2004 Cadillac CTS

Reduced Engine Power, Service Engine Soon (SES) Light with One or More DTCs P0121, P0221, P2119, P2122, P2138, P2176 (Replace Throttle Body Assembly and Harness Connector to Throttle Body) #05-06-04-032A - (May 25, 2005)

This bulletin is being revised to include additional diagnostic information on throttle body assembly harness connectors. Please discard Corporate Bulletin Number 05-06-04-032 (Section 06 - Engine).

FIGURE Replacement Throttle Body Assembly Harness Connector(c)

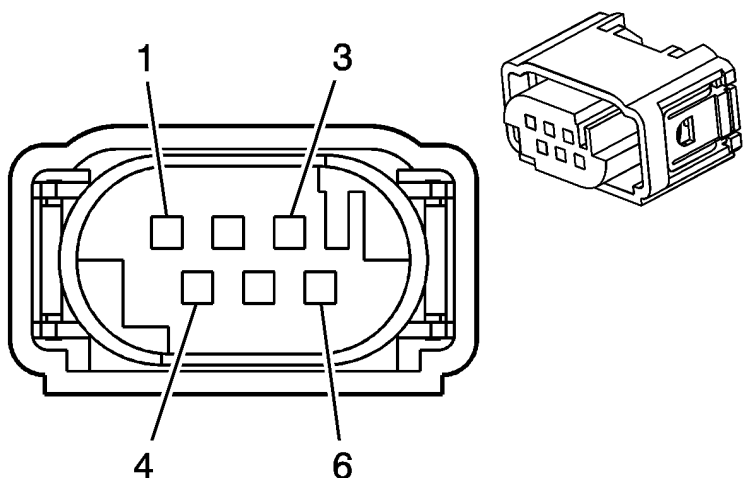
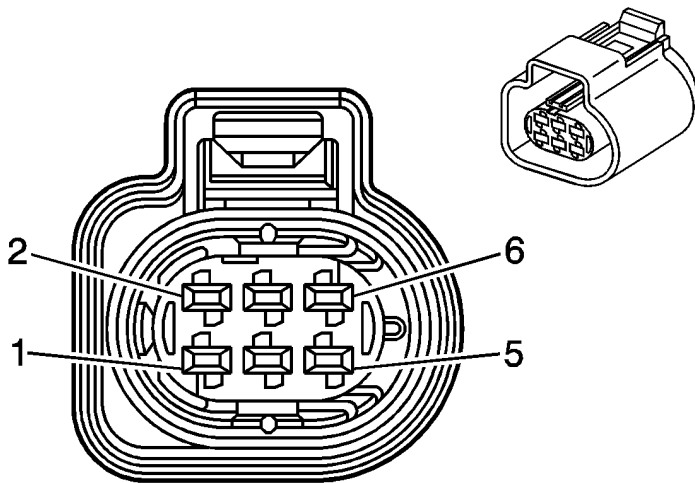
The condition may be caused by a poor connection at the throttle body electrical connector.

Refer to Replacement Throttle Body Assembly Harness Connector and wiring schematic for the installation of the Replacement Throttle Body Harness Connector, P/N 88988585.

Technicians are to replace the following parts.

- Throttle Body Assembly, P/
N 12589056
- Throttle Body Seal, P/
N 12581398
- Throttle Body Harness Connector, P/
N 88988585

Important: Use splice seal connectors when replacing the throttle body harness connector.
